**Re: Killeens Waste Water Discharge Licence Application – Ref D0329-01 - Response to Regulation 18(3)(b) Notice.**

Job Title:  
Killeens  
Wastewater Discharge  
Licence Application

Drawing Title:  
Response to Regulation 18(3)(b)  
Updated map of Agglomeration

Scales: 1:5,000 @ A3	Surveyed by: TOH	Drawn by: TOH
Designed by: T.O.H	Checked by: D.O.S	Date: February 2009
Drawing number: Reg. 18(3)(b) - Map 1	Rev:	-

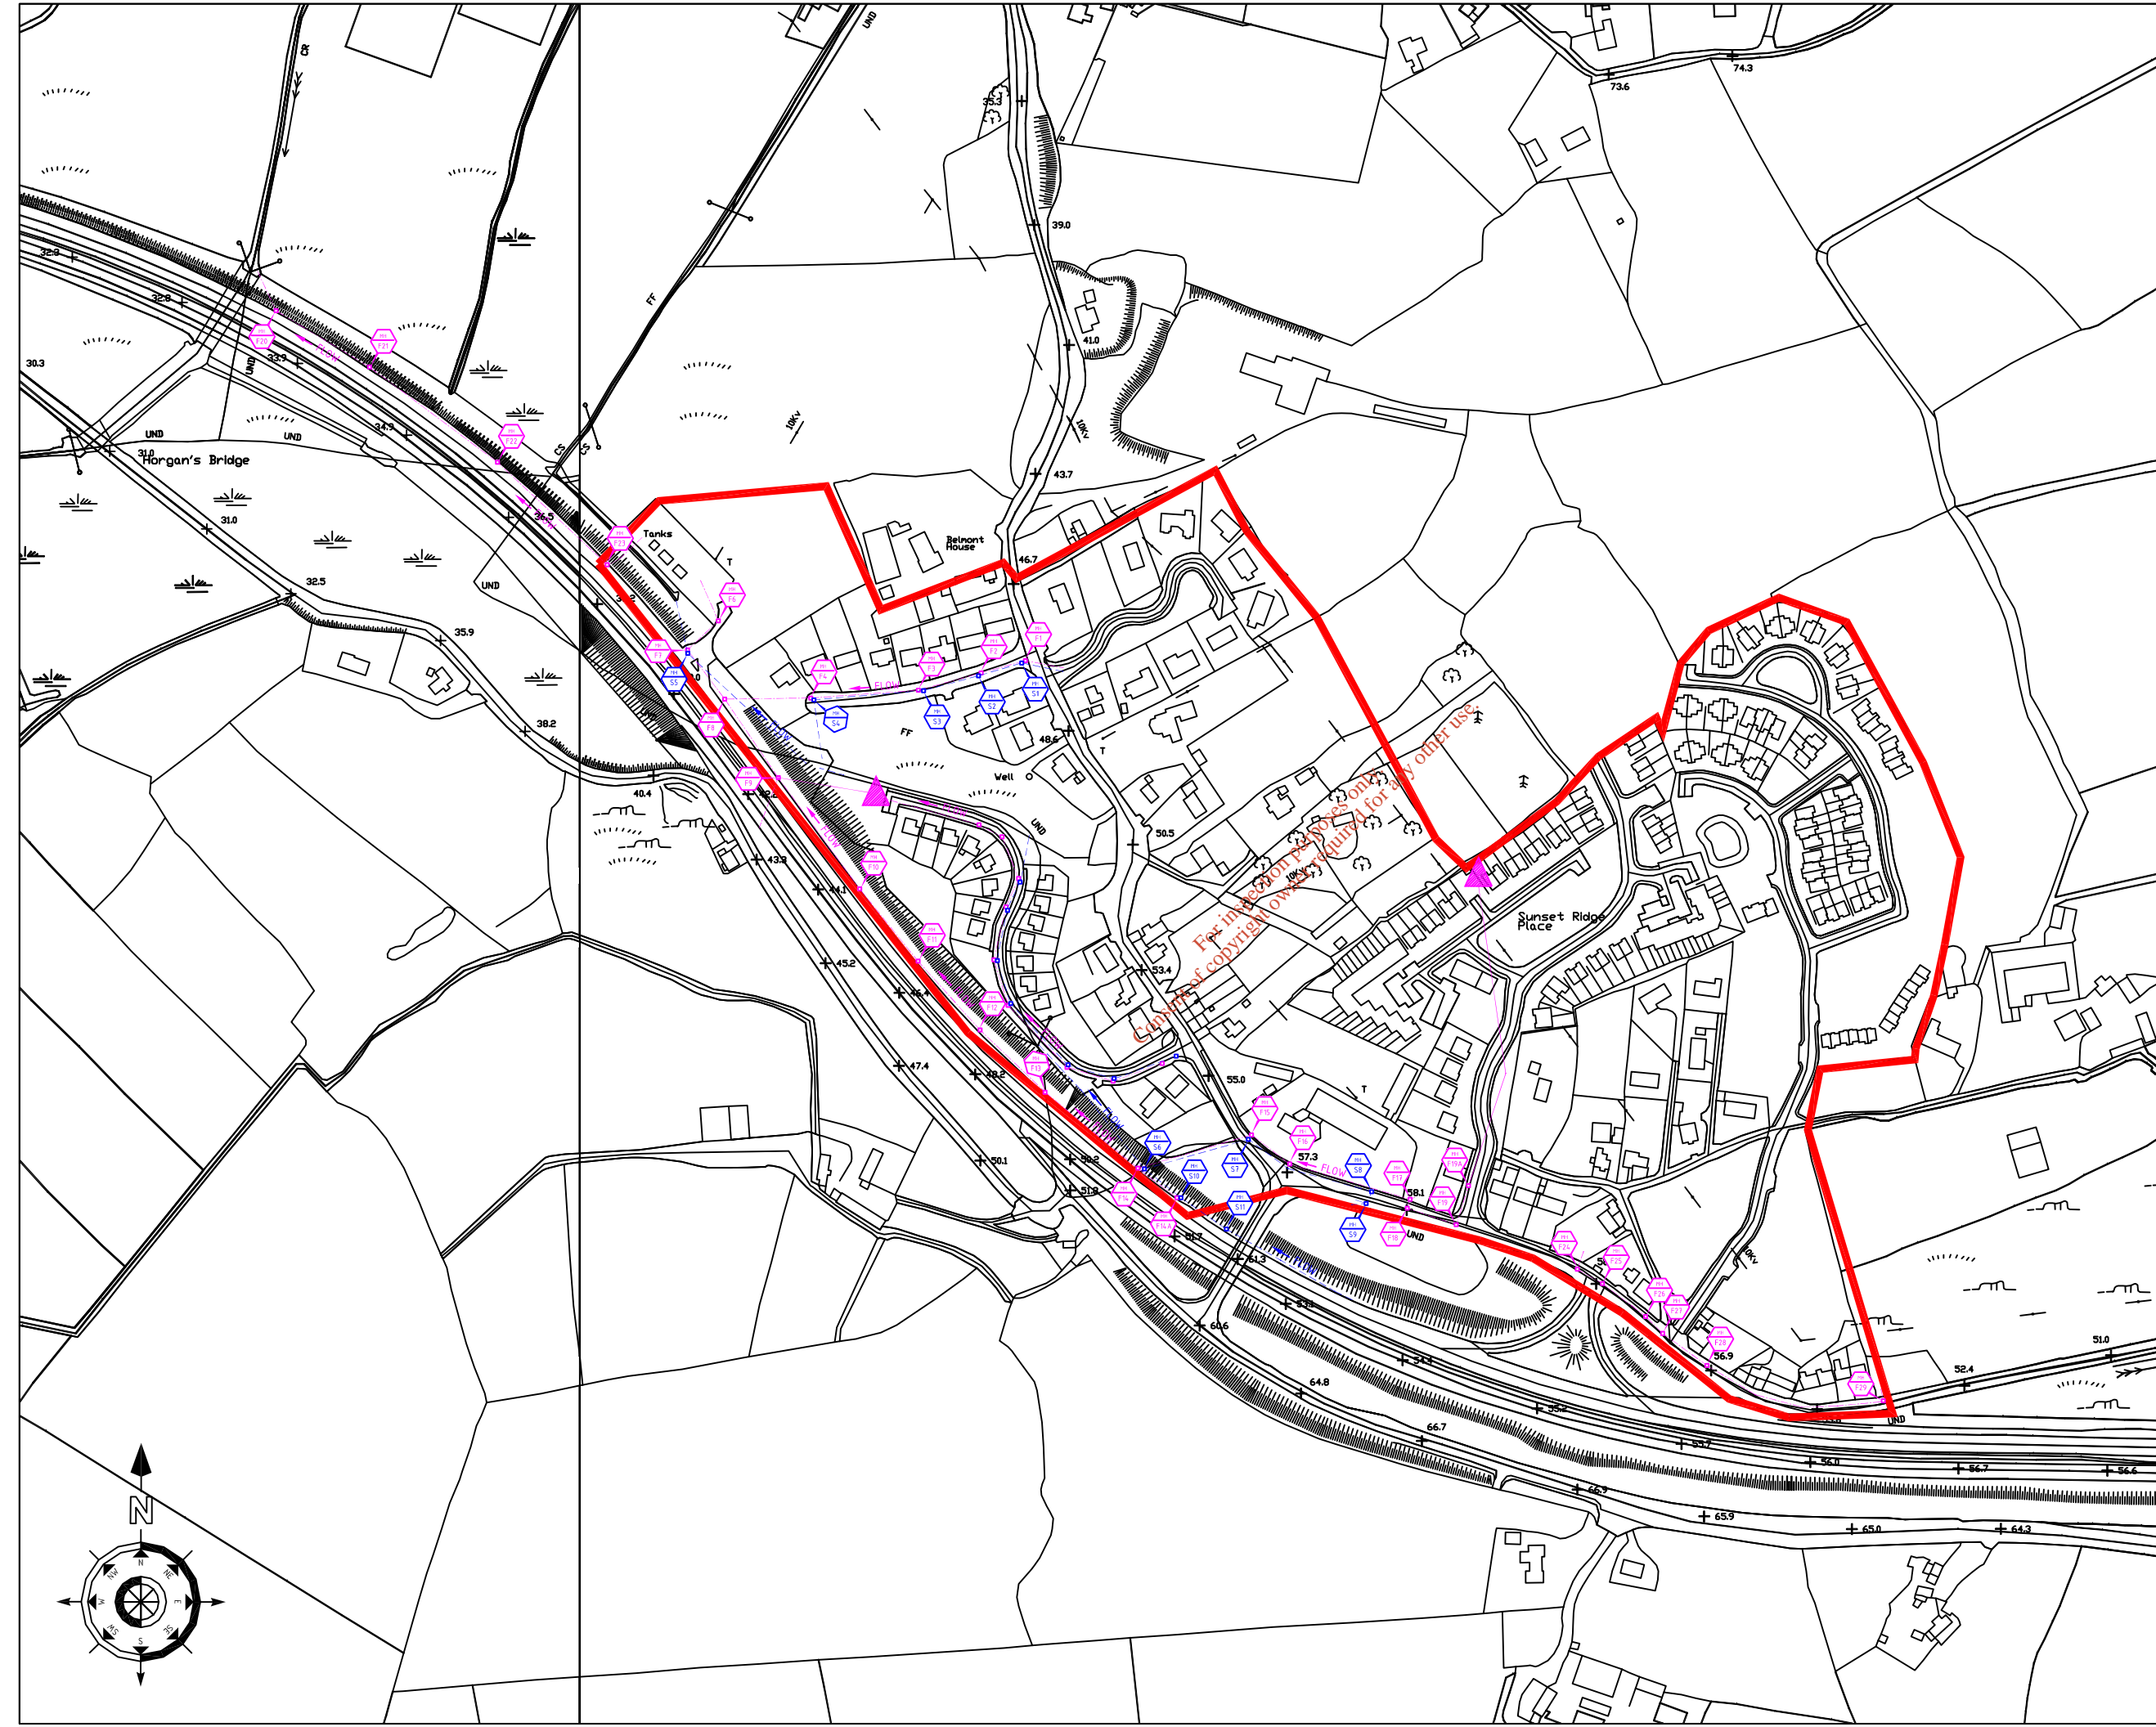
1. Updated map of agglomeration to include all aspects of the waste water works.

An updated drawing ref Reg. 18(3)(b) - Map 1 is enclosed. Drawings of the sewers in new housing estates are not available.
